RE: ENGINEER'S CERTIFICATION FOR SEVEN BAR NORTH - UNIT 5A
RECEIVED SEPTEMBER 16, 1996 FOR FINANCIAL GUARANTY RELEASE
ENGINEER'S STAMP DATED 9/9/96 (A-13/D7A1)

RE: GRADING PLAN FOR SEVEN BAR NORTH - UNIT 5A (A-13/D7A1)
RECEIVED OCTOBER 31, 1995 FOR R GRADING, FINAL PLAT & W.O.
ENGINEER'S STAMP DATED 10/31/95

RE: GRADING PLAN FOR SEVEN BAR NORTH - UNIT 5A [redacted]
RECEIVED SEPTEMBER 6, 1995 FOR R GRADING, FINAL PLAT & W.O.
ENGINEER'S STAMP DATED 9/5/95

SEVEN BAR NORTH - UNIT 5A
STORM DRAIN PLAN & PROFILE
SEVEN BAR LOOP ROAD

SEVEN BAR NORTH - UNIT 5A
STORM DRAIN PLAN & PROFILE
LINE "A"

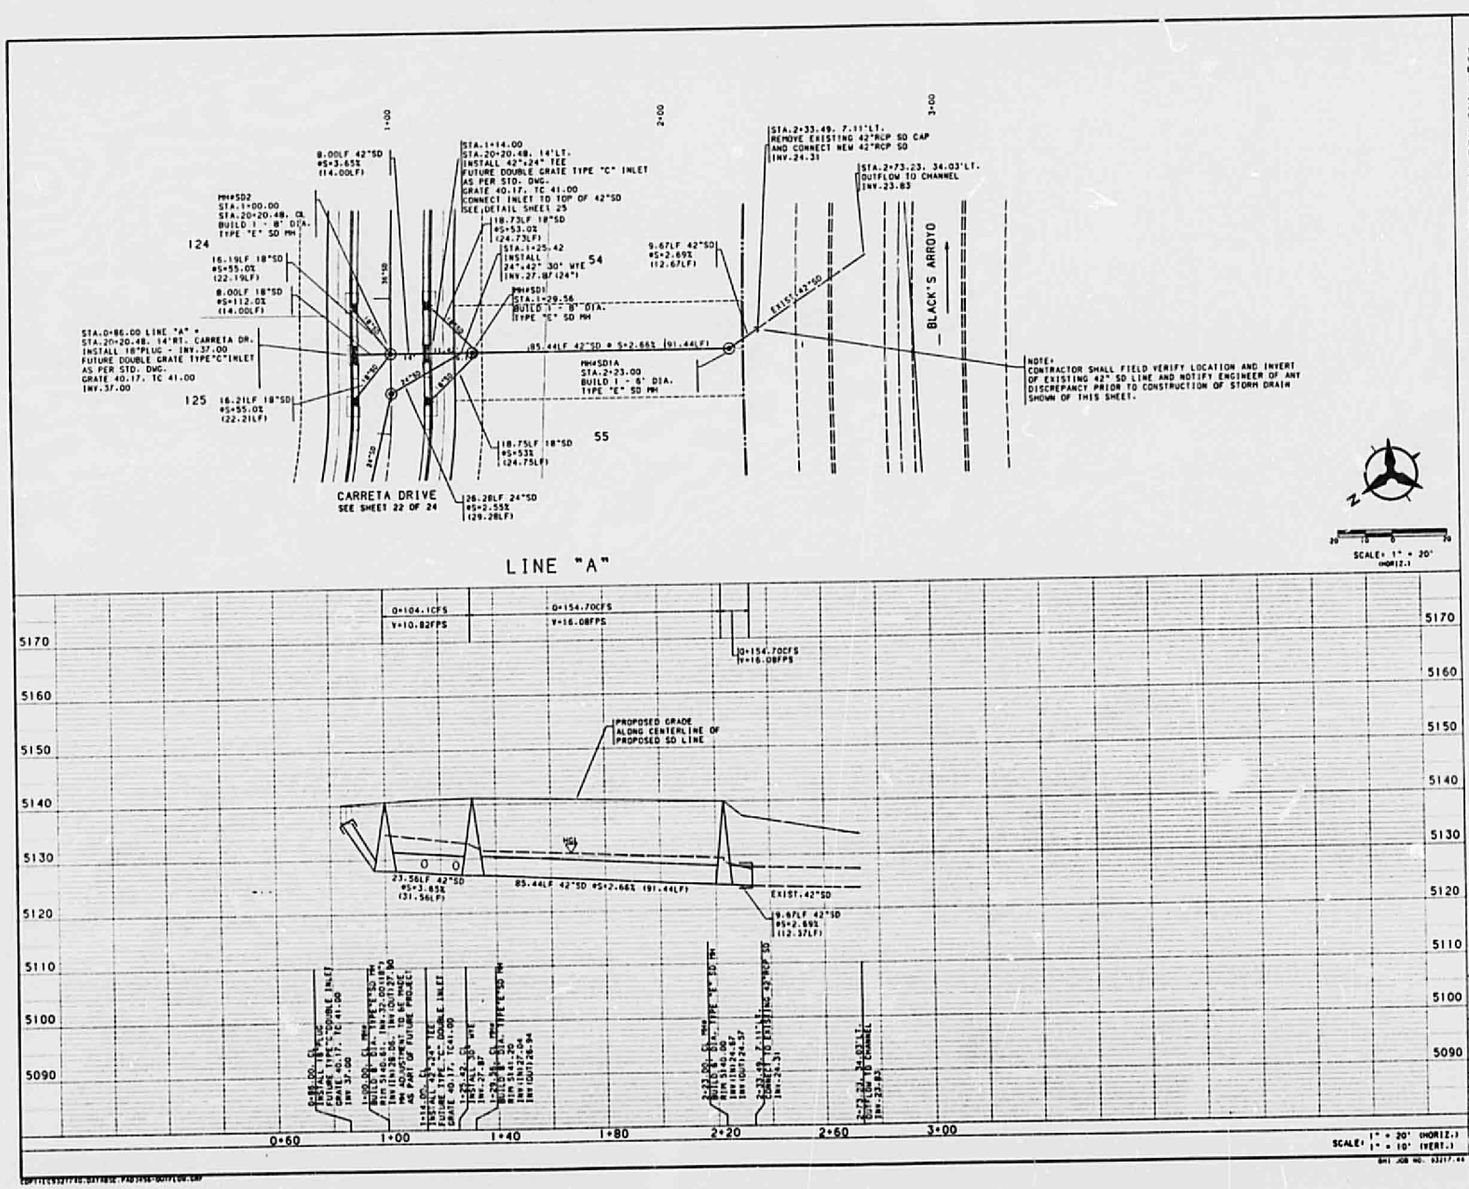
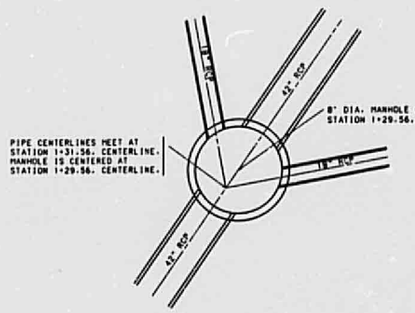
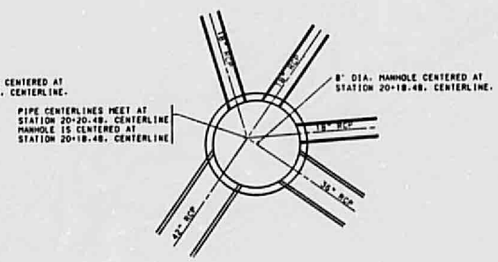
Use a manhole instead of a tee where pond outfall connects to storm drain because of maintenance requirements. Indicate drainage easements required for the diversion channel, sedimentation pond and storm drain.
